ADDITIONAL INFORMATION REQUIRED FOR

THE
ANACONDA COPPER COMPANY'S
JACKPILE-PAGUATE
RECLAMATION PLAN
October 27, 1980

Re: Letter - R. D. Lynn, Anaconda Copper Co.,
October 28, 1980

JACKPILE-PIT
DUMP CROSS
SECTION
- LCG

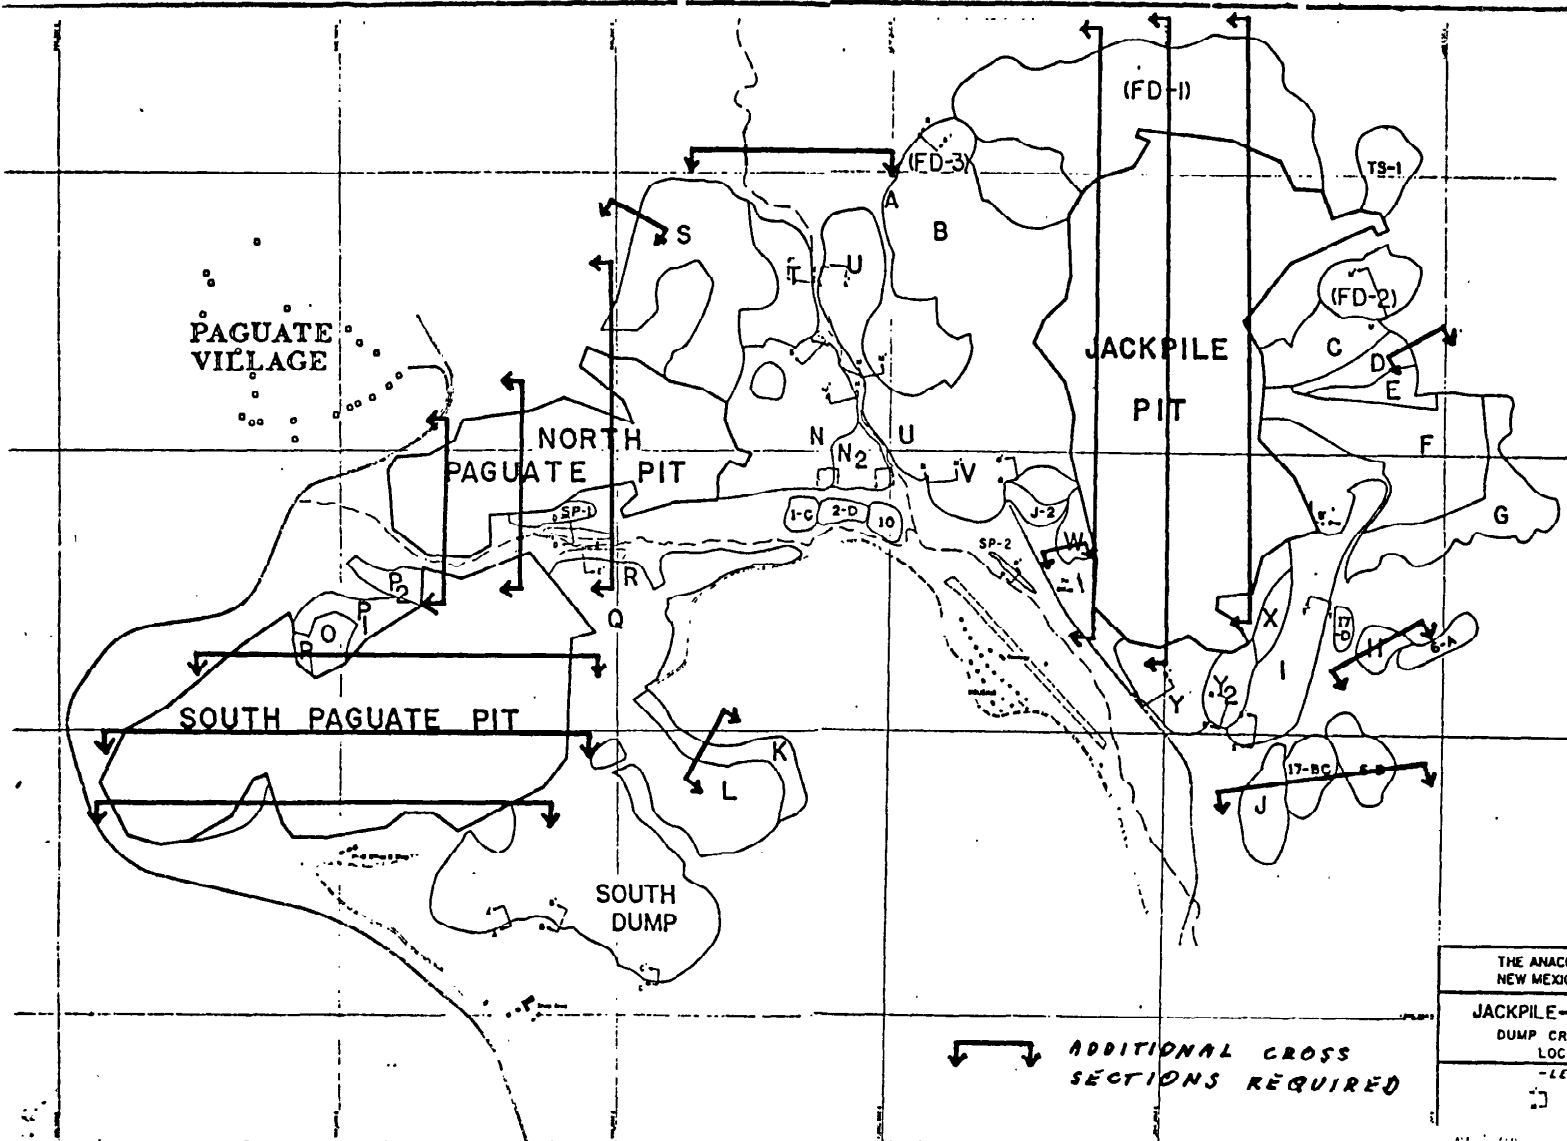
1. To adequately assess the final reclaimed land forms, additional detail must be provided. Please submit the cross-sections shown in red on the attached map.
